MONTGOMERY COUNTY PLANNING DEPARTMENT
THE MARYLAND-NATIONAL CAPITAL PARK AND PLANNING COMMISSION

**Staff Report: Gallery Park (previously approved as "Eastside")
Preliminary Plan Amendment 120050101A
Site Plan Amendment 82005038A**

DESCRIPTION: Revision of lot and building layouts, reduction of units, and modifications to the conditions of approval for 256 units on approximately 23.82 acres in the PD-11 Zone; located at 13000 Shawnee Lane, approximately 80 feet east of Gateway Center Drive in the Clarksburg Master Plan area.

Comparison of Roadway, Open Space, and Building Layouts

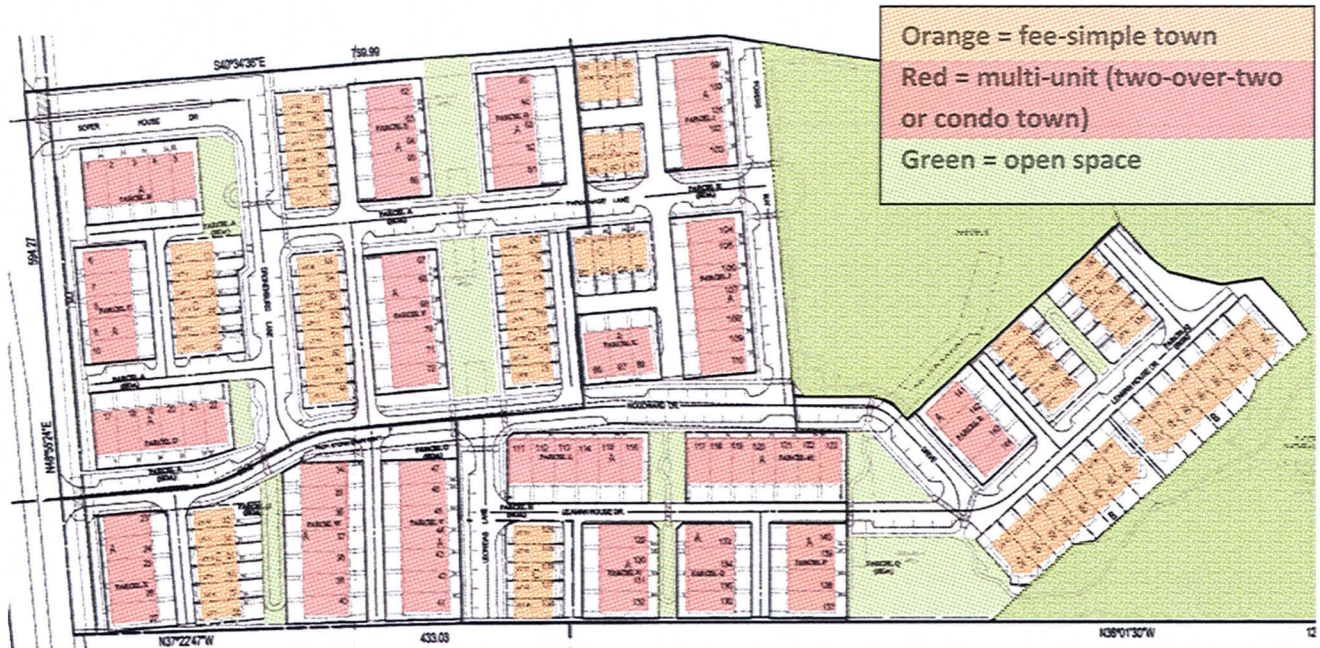
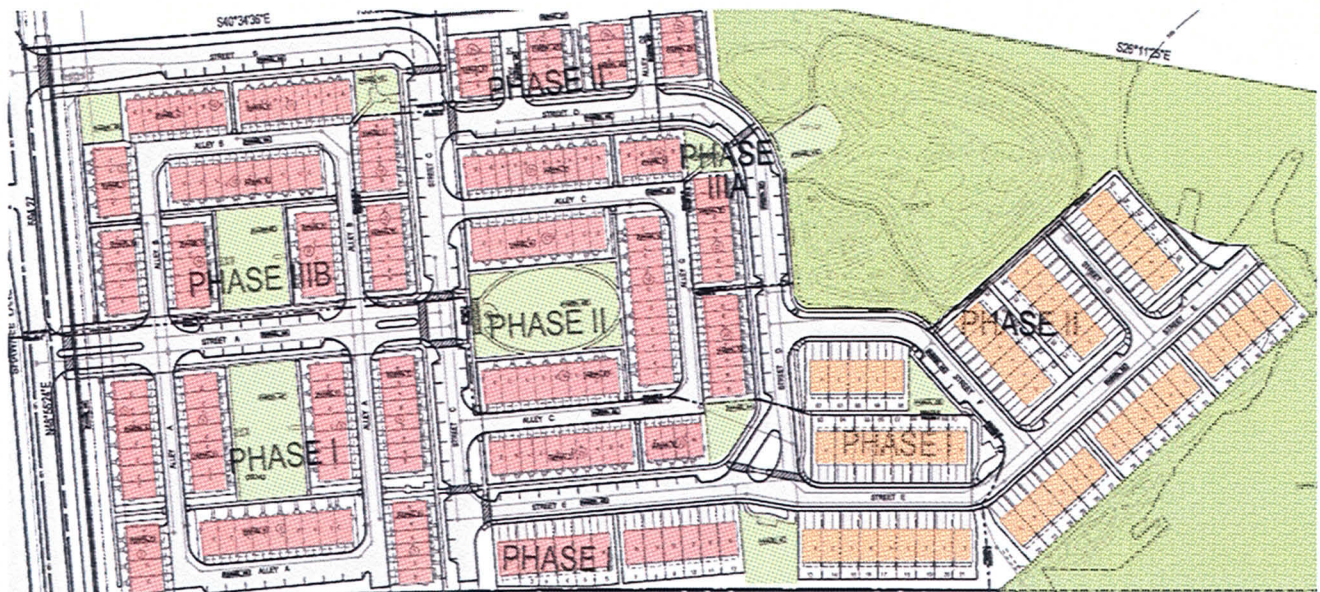
The amended plan enlarges and centralizes the right-in/right-out entrance from Shawnee Lane to act as the primary spine for the site. The eastern entrance remains largely unchanged and will continue to provide a possible shared access point to any redevelopment of the bus depot site. The axis of the central spine road terminates in a large community open space and is flanked on each side by additional open spaces midway along its length. Each of these three large open spaces is bordered by condominium townhomes that front the open space on three sides and have vehicular alleys behind them shared by additional rings of townhomes. A few small groupings of townhomes radiate out from this pattern. Finally, a spur road along the southwest edge of the site provides access to the sticks of fee-simple townhomes, which are largely surrounded by conservation and stormwater areas. The tot-lot that was previously located at the end of a stick of townhomes and surrounded by streets has been tucked into the stormwater facility area. Parallel parking is provided along the internal streets in addition to parking on driveways and within garages.

Parameters for Recommended Tot Lot

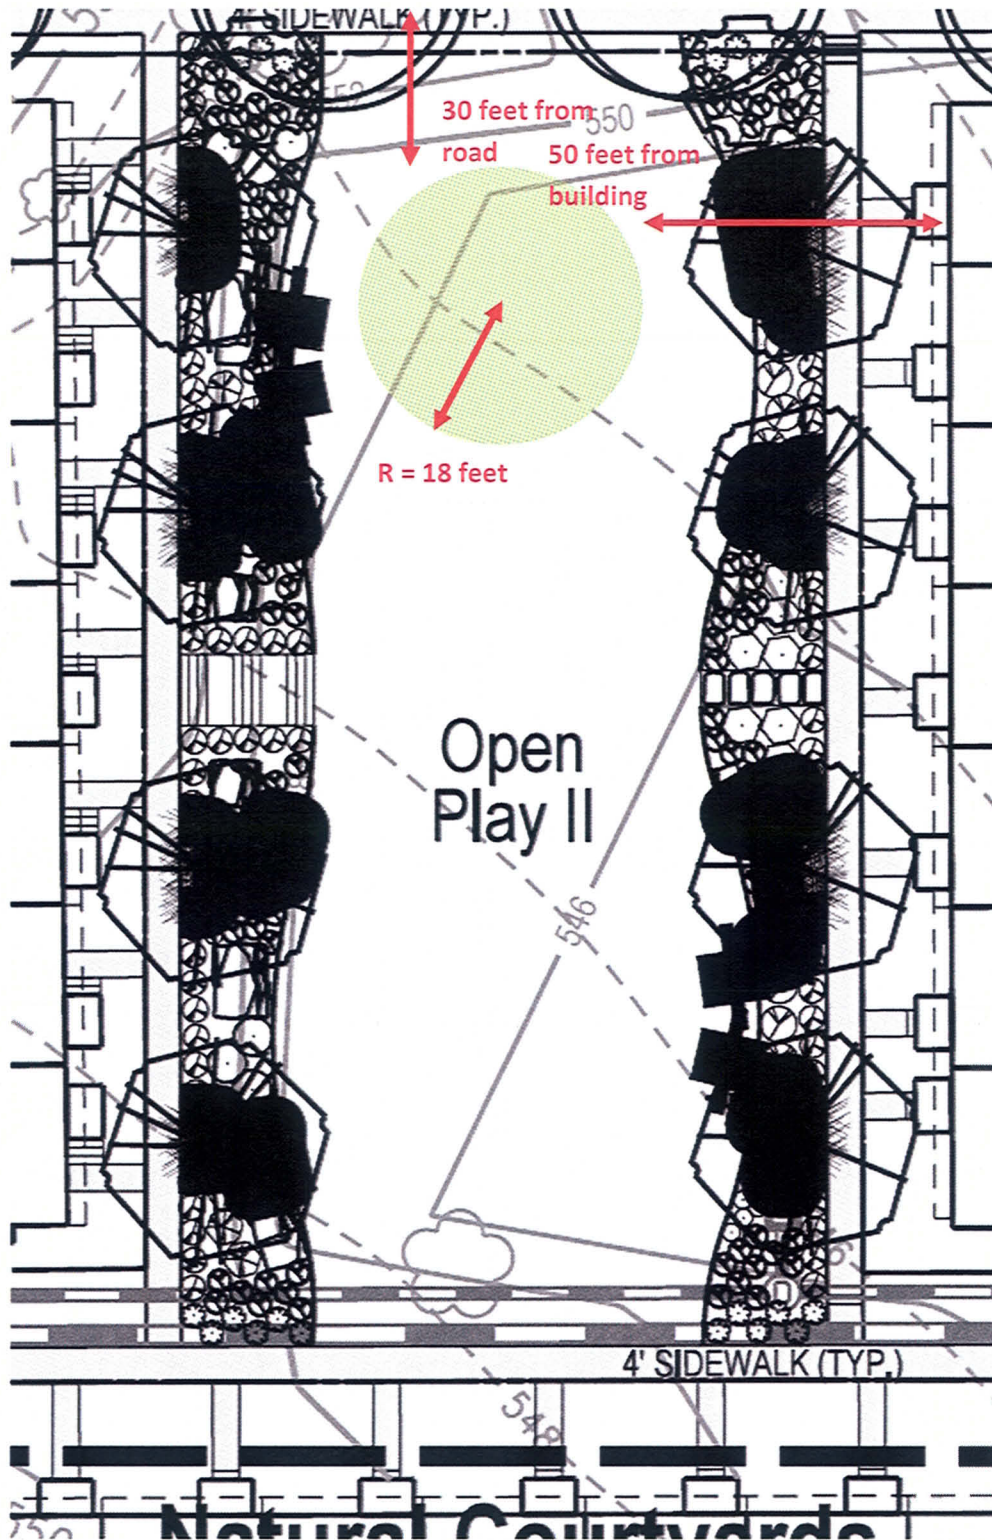
The recreation opportunities – especially for children – has led Staff to conclude that a greater diversity of directed play options would greatly benefit this community that will have upwards of a couple hundred children living in it. Tots and children have different requirements and benefit from a diversity of apparatuses. Staff recommends, therefore, that the proposed “tot lot” be slightly modified to fit the specifications of a “play lot” and that a separate, more focused and simple tot lot be provided in a more central area – specifically, carved out of the easternmost open play area.

1. The mini moon ladder in the proposed tot lot should be changed to something requiring balance and/or creative play. Examples of balancing apparatuses include odd shaped balance beams and stepping stools or stumps. Examples of creative play apparatuses include mock pirate or Viking ships or trains. This will allow it to qualify as a “play lot” at its existing size.

2. A simple, age-appropriate tot lot should be provided in the larger open play area II. This tot lot should include low climbing, swinging, sliding, and other activities. Examples of apparatuses that provide such uses are play houses, sand boxes, and swing sets.

3. This tot lot must be around 1,000 square feet, which allows more than 5,000 square feet of the area to remain as lawn to continue to meet the dimensions required by the guidelines. No fence should be provided unless within 30 feet of the road, one shade tree should be planted near the center of the area.

Illustrative Plan

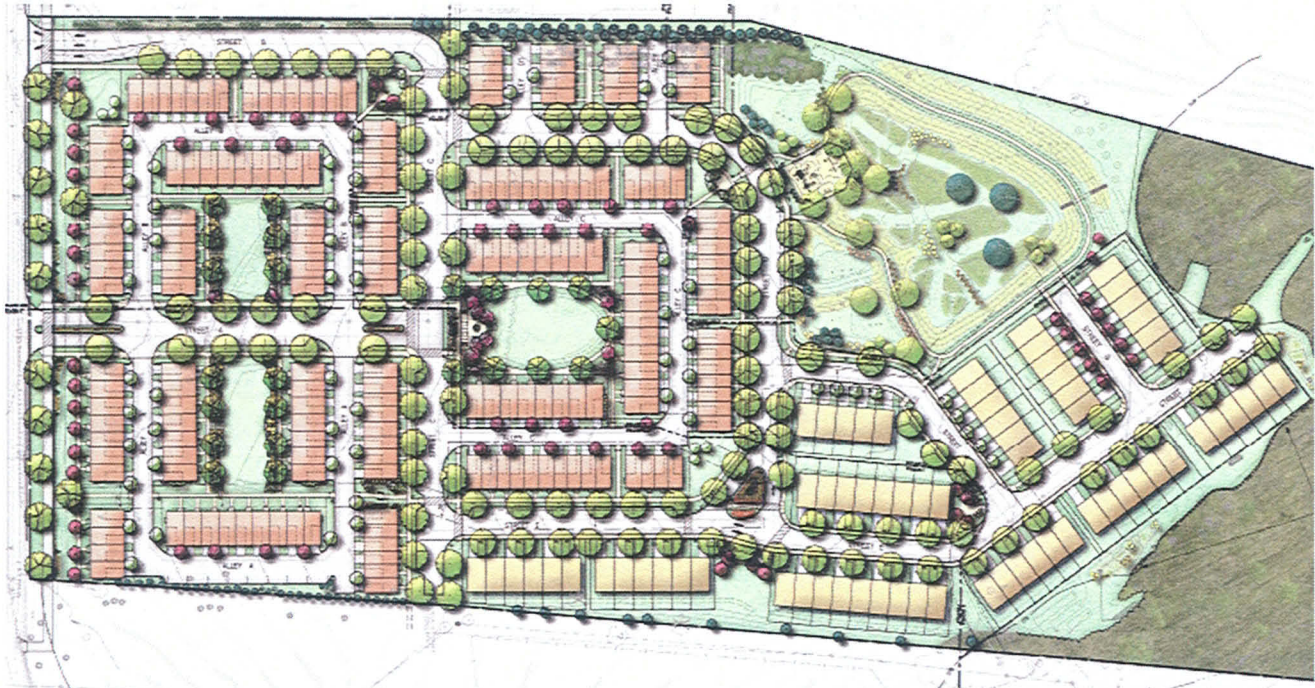
The building layout has improved compared to the originally approved site plan. The units are more logically located around a hierarchy of streets and open spaces and situated to reduce the amount of paved streets necessary. Likewise, the street network is more logical and, therefore, navigable. This layout also allows for 20 additional parallel parking spaces for visitors in a less fractured pattern.
